For Immediate Release: June 1, 2021

New! Factory Team RC8B3 HD Gearbox

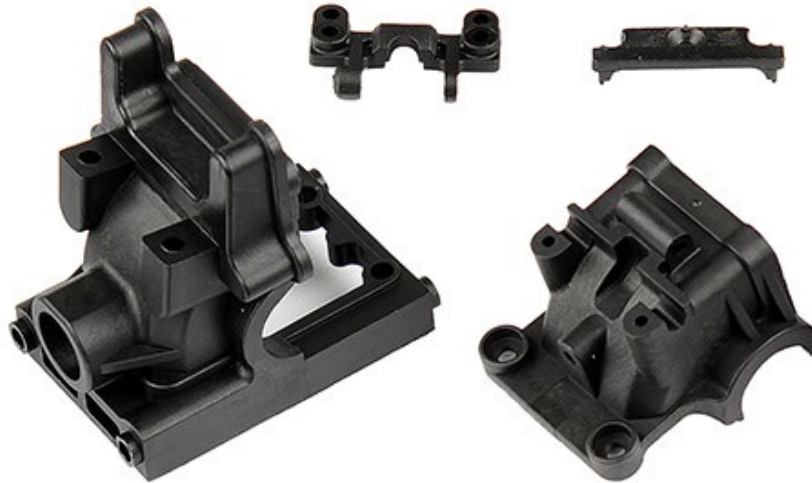
This new HD (Heavy Duty) material for RC8B3 gearbox is an excellent upgrade for the RC8B3 and RC8T3 series! The stiffer HD high-temp polymer material gearbox has a better bearing fit. Extensive testing with the RC8T3.2 platform shows an incredible jump in durability, and the HD material maintains consistent gear mesh over long main events.

Each spare parts package contains a complete gearbox as shown.

Pro Tips: Take note of the differential and suspension arm shimming:

- The diff will need to be adjusted from the stock #81015 gearbox. Recommended to start with one thin (0.1mm, the thinnest available) on each side.
- To fine tune the suspension arm shimming on the inner hinge pin, use 0.9 or 1.0 caster adjustment shims from the #81446 RC8B3.2 Shim Set, and you can trim off the pull-tab for ground clearance.
